**CITY OF DELAWARE  
PLANNING COMMISSION  
AGENDA  
CITY COUNCIL CHAMBERS  
1 S. SANDUSKY ST.  
7:00 P.M.**

April 4, 2018

2018-0429: A request by Ohio Wesleyan University for approval of a Combined Preliminary and Final Development Plan for the House of Black Culture at 65 Oak Hill Avenue zoned PO/I (Planned Office/Institutional District).

2018-0378: A request by Vincent Romanelli for approval of an Amended Preliminary Development Plan for Glenross North Subdivision to include a pool with a pool building and parking lot to the central park of a 196 single family lots on approximately 100 acres located just east of Glenn Parkway and north of The Glenross Golf Club on property zoned R-2 PMU (One-Family Residential District with a Planned Mixed Use Overlay District).

Architectural Site Plan

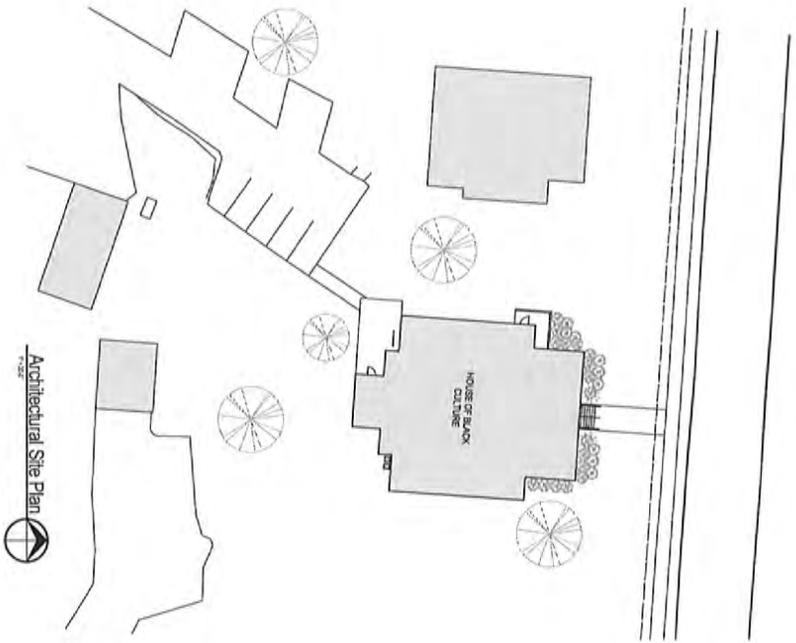
- **LANDSCAPING:** Along with preserving four existing trees, the applicant would have to install the appropriate foundation landscaping per the zoning code. All landscape plans would need to be submitted, reviewed and approved by the Shade Tree Commission.

- **TREE PRESERVATION:** The site plan identifies two large trees (approximately 48 and 55 caliper inches respectively) located on the east side of the new house that would be removed in the construction of the new house. Also, the plan identifies four large trees being persevered. If, for some reason, they are removed during construction the total caliper inches would have to be replaced per Chapter 1168 Tree Preservation Regulations. Ohio Wesleyan University established a "tree bank" to accommodate the replacement of any trees removed in any University related projects. The University plants trees on a yearly schedule within their campus which would have to be approved by the City to ensure it meets any replacement requirements (103 caliper inches for the House of Black Culture) and minimum planting requirements to achieve compliance with Chapter 1168 Tree Preservation Requirements, while satisfying replacement for removal requirements

4. Approximately 103 caliper inches of trees shall be replaced for the House of Black Culture to achieve compliance with Chapter 1168 Tree Preservation Regulations and are allowed to be planted elsewhere on the campus per the previously approved OWU planting methodology and current tree preservation chapter of the Zoning Code.

5. The landscape plan shall be submitted, reviewed and approved by the Shade Tree Commission.
6. Any lighting plan shall be submitted, reviewed and approved by the Chief Building Official.

PRELIMINARY  
DEVELOPMENT  
PLAN AMENDMENT

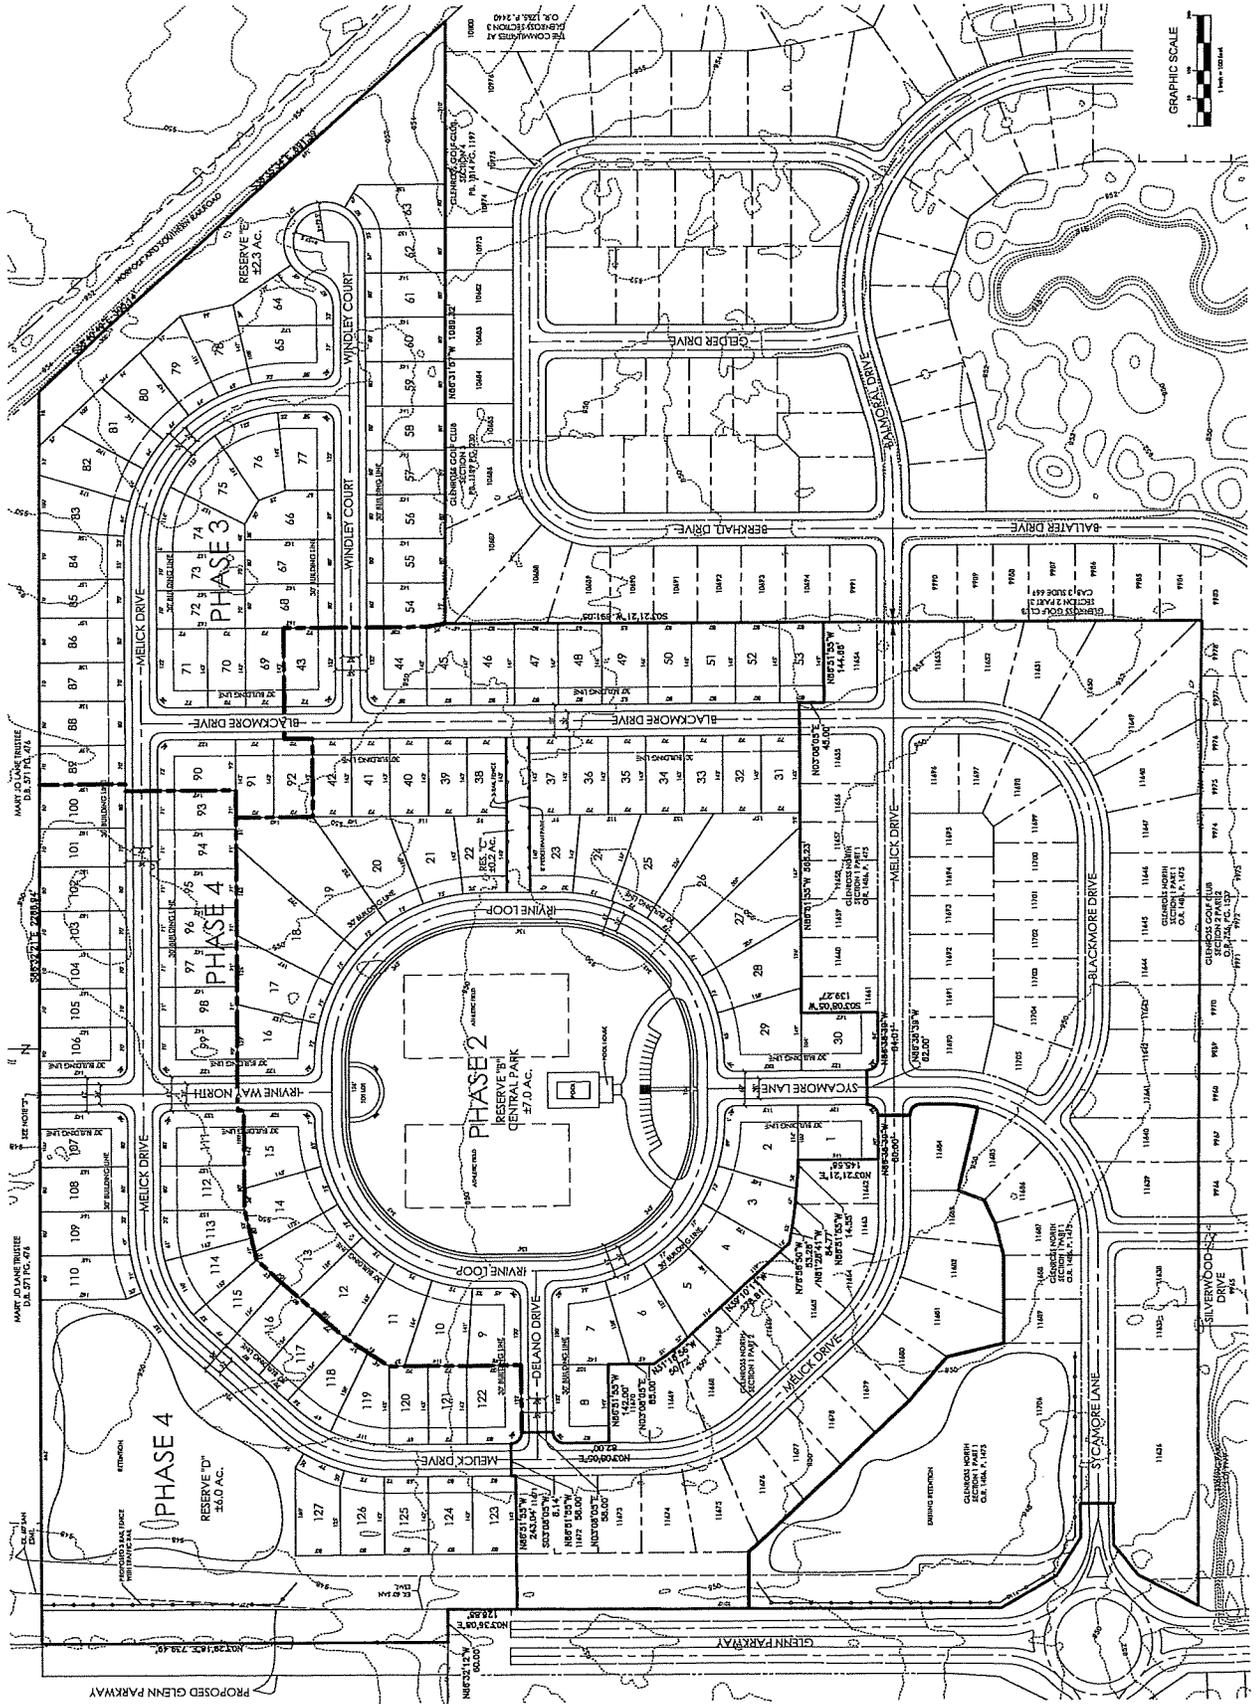
supplement the proposed 20 space private parking lot in the park area. If parking becomes a problem in the future, the developer would have to construct the required amount of parking in the central park area to accommodate any such problems at the direction of the City. Staff recommends the applicant identify 20 additional spaces on the plan that could be built if a parking issue occurs in the future and the city requires these to be built at that time. There is no compelling reason to pave over what otherwise would be green park space for vacant parking lots. Some of the current amenities include active multi-purpose fields, passive pedestrian walking paths, a tot lot, a gazebo, benches and trash receptacles. The tot lot would be relocated to the northern portion of the central park from the current location of where the pool and pool building are proposed.

- **LANDSCAPING PLAN:** The applicant has provided minor landscape revisions around the relocated tot lot, proposed pool, pool building and parking lot to supplement the previous proposed landscaping plan. The revised landscape plan would need to be reviewed and approved by the Shade Tree Commission.

- **TREE PRESERVATION:** The proposed pool, pool building and parking lot would not remove any additional trees.
- **LIGHTING PLAN:** Any lighting associated with the pool, pool building and parking lot would have to be submitted, reviewed and approved by the Chief Building Official and achieve compliance with the zoning code prior to Final Subdivision Plat approval of the subject phase.

1. The Applicant needs to obtain final engineering approvals, including any storm water and utility issues that need to be worked out through the Engineering and Utilities Departments. All comments regarding the layout and details of the project are preliminary and subject to modification or change based on the final technical review by the Engineering Department.

2. The revised landscape plan shall be submitted, reviewed and approved by the Shade Tree Commission.
3. Any lighting associated with the pool, pool building and parking lots shall be submitted, reviewed and approved by the Chief Building Official that complies with the minimum zoning requirements prior to the engineering drawing approval.
